Planning Approval Consistency Assessment Form

SYAB – access and temporary construction area

SM ES-FT-414

Sydney Metro Integrated Management System (IMS)

SYAB Pedestrian Access

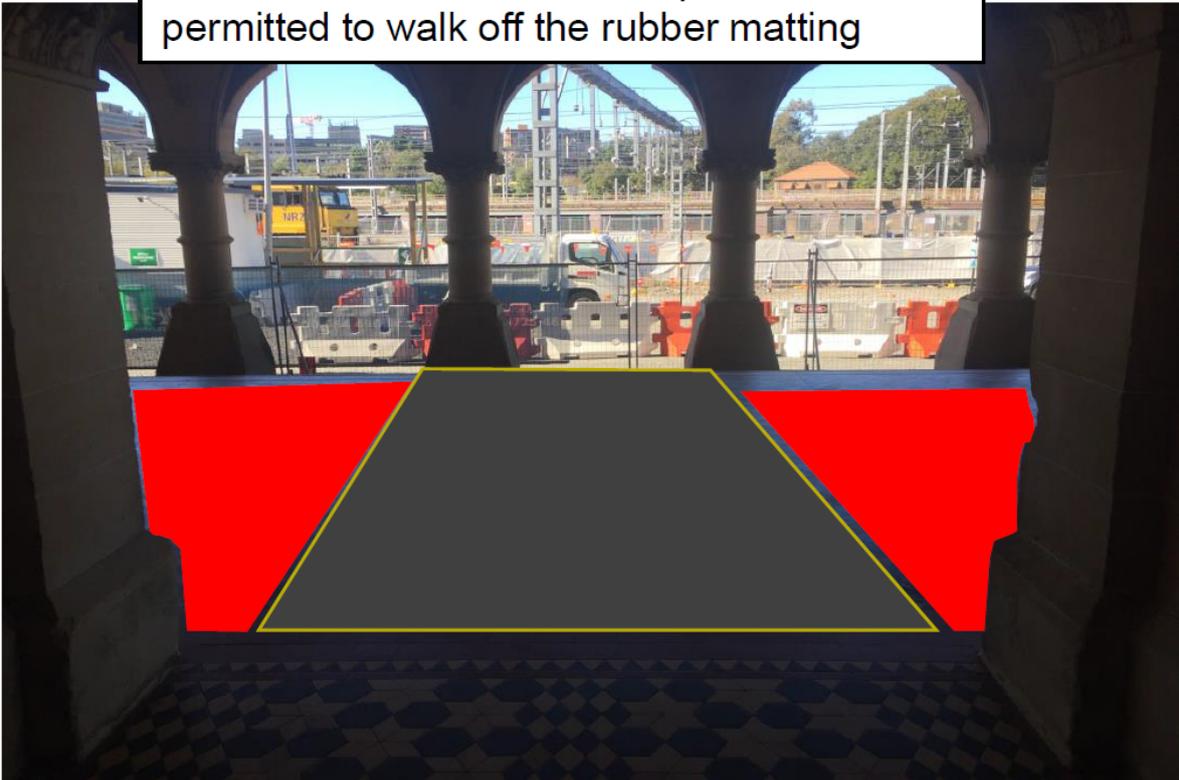
If LOR are proposing to continue the rubber matting over the entire path including the stairs that isn't a problem, but it would be good to see how that is proposed to be resolved.

There are also proprietary systems of stair protection that I have used on previous projects. They range from dense cardboard products that would require ongoing occasional replacement, through to more dense plastics (eg. <http://www.protectagroup.com.au/shop/item/product-105>). Another alternative would be to box out the stair with a timber frame, over clad with plywood or similar. The weight of the timber could mean that it might be able to freestanding with no need for fixing, or it could be weighted etc, instead of mechanical fixing.

- Slide 5 – All references to 'access' should be updated to state 'pedestrian access' as previously agreed - **Updated**
- Slide 5, paragraph 3 – ..only soft nylon brushes will be used on the protected surfaces. Cleaning at the conclusion of the pedestrian access arrangements will be agreed in consultation with Sydney Trains Heritage. (add text in red) – **Added**

- Slide 5, paragraph 4 – this point needs to address the stair nosings on the Regent Street side of Mortuary Station. There are a set of two sandstone steps in order to get up to the platform tiled level. What protection is proposed for those stairs? - **The rubber matting will run the whole length of the pedestrian walkway, can you advise if there is any particular protection methods as we don't want to create trip hazards on the steps & we cannot attach anything physical??**

- Slide 5, paragraph 6 – the Dilapidation/condition survey has not been submitted as agreed. Has this been undertaken? If works are to commence tomorrow in setting up the temporary arrangements the condition survey needs to be undertaken prior as required by the project condition (Condition E58/59) – **Delap is scheduled for Tuesday 15/08/2017**

- Slide 5, paragraph 7 – Notes that regular monitoring is take place. Include note on how this will be reported/recorded? Ie through the Environmental Representative's inspections – **added by environmental rep**

1. Slide 5 – the gate will be open from 7-8am. What does this mean? The gate is open and anyone can walk through and gain access to the building, construction site and rail corridor? Is this gate manned between those hours? Additional detail required? **During the hours of 7-8 LOR will have the gate manned at all times to allow workers to get into site. After 8am the gate will be locked & all access will require a person to call through where by a LOR rep will come to open the gate.**

2. Slide 8 – pedestrian movement barriers shown. Sydney Trains believes it was agreed that this wouldn't be necessary as all pedestrian movement would be escorted. This makes the access point very visual. – **slide updated with barriers removed.**

3. No mapping of exclusion areas. - **Slide updated to show exclusion zone**
4. No mention of protection for nosings etc. Extension of the rubber probably not sufficient. – **the scaffold access stairs will be cantilevered over the edge of the platform thus this will provide the protection for the nosings**

Under no circumstances are pedestrians permitted to walk off the rubber matting
